From: Amanda Scholes on behalf of Planning.Responses
Sent: 25 April 2019 08:50
To: Planning Scanning
Subject: FW: Planning Application for 2no. additional dwellings to 6 Manor Road, Rustington
Attachments: Side Elevation_A4_scale 1_50.pdf; Front Elevation_A4_scale 1_50.pdf

Planning Application No. R/72/19/PL.

Further to our telephone conversation on Monday, 15th April, 2019, in connection with the above application for the two proposed detached chalet bungalows in addition to the existing detached bungalow on the site, we wish to raise an objection to the current scheme and give our concerns regarding the size, heights and positioning of the proposed chalet bungalows.

FRONT ELEVATION

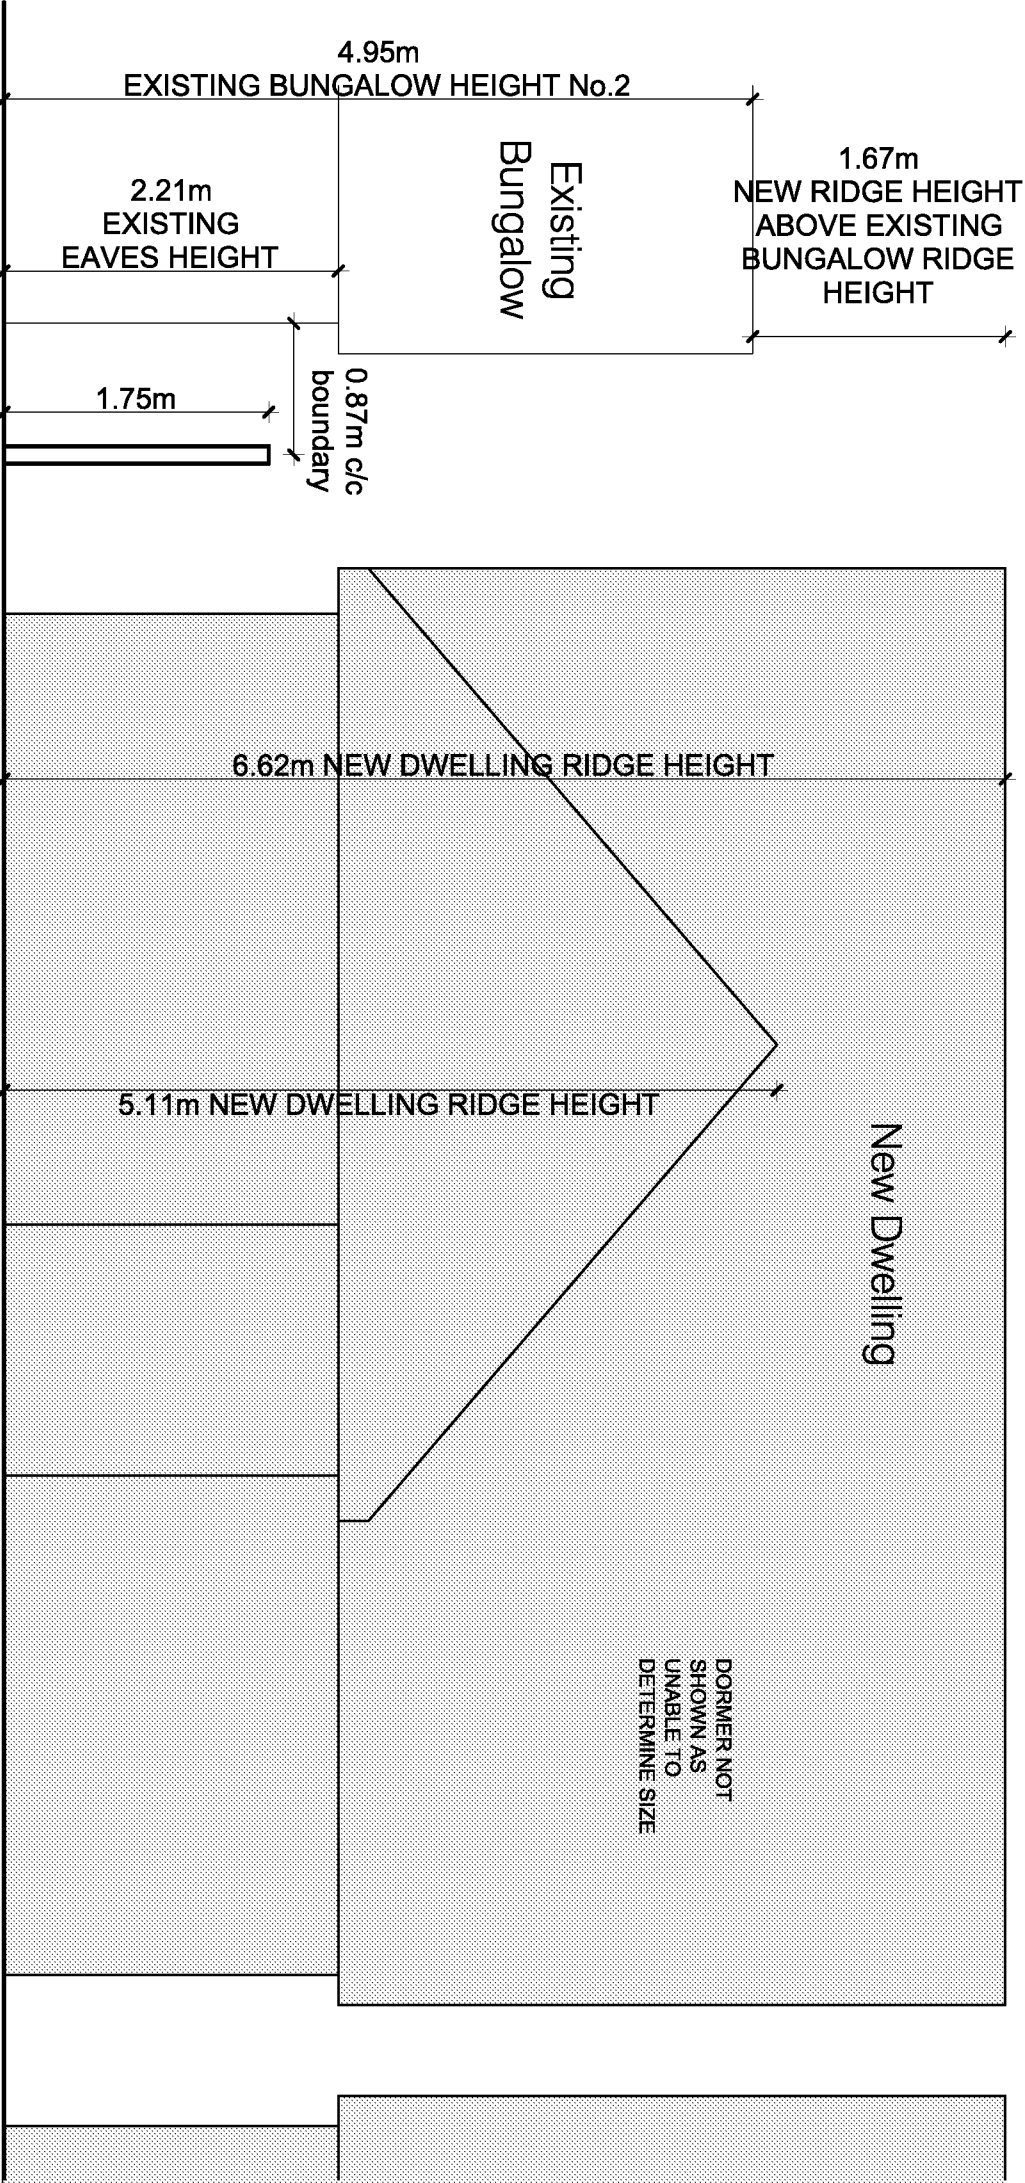
As discussed, I have attached two A4 1/50 scale drawings for you to see, showing a part front elevation and side elevation showing how our existing bungalow and the new chalet bungalow will likely look next to each other as at present the ridge height of the proposed chalet bungalows will be approx. 1.67m higher than the ridge height of our bungalow. Whilst the proposed dormers are estimated the overall heights and width and length of the new chalet bungalows are the dimensions given on the application drawings.

Even the lower front projection of the proposed chalet bungalows, which has a ridge height of 5.11m is higher than our existing bungalow.

You will see from the attached drawings the impact the new chalet bungalows will have against our property.
